Memorandum

To: Rick Bondar
From: Mo Faghihi
Date: February 8, 2016
Re: RTRP Conflict Areas with PA-13 Site (APNs: 160-050-027, 160-050-048, & 160-040-039)

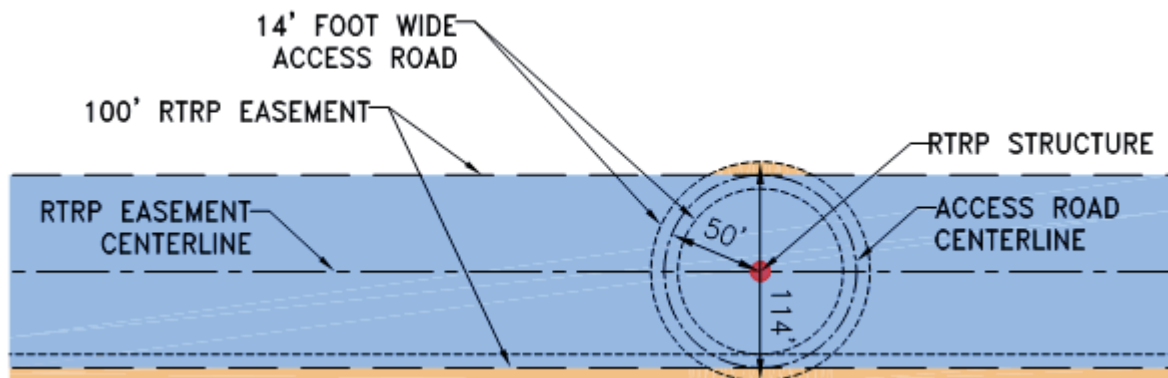
This memo concerns the site consisting of approximately 102.5 acres (after the completion of a Lot Line Adjustment being processed) north of Limonite Avenue, adjacent to the I-15 Freeway, depicted in the attached exhibit. Based on the proposed alignment of the RTRP project, there will be significant impacts to the PA-13 Site property:

1. The area is currently planned for Medium Density Residential uses per the I-15 Corridor Specific Plan (SP 266). The proposed RTRP alignment would eliminate approximately 6.4 acres of One-Family Dwellings (R-1) from the site.

2. Webb undertook the engineering to analyze the residential lot yield on the PA-13 Site consistent with the existing zoning. Webb used the adjacent Harvest Villages at the Vernola Ranch (Tentative and Final Tract Maps 33428-1, -2, and -3) as a guide to how the City of Jurupa Valley wants to implement completion of the Master Planned Community. The reduction of approximately 6.4 acres of One-Family Dwellings (R-1) will reduce the potential residential units by approximately 22 units (assumes a density of 3.5 dwelling units per acre which is the average of the allowable Density for Medium Density Residential per the General Plan = 2 – 5 dwelling units per acre).
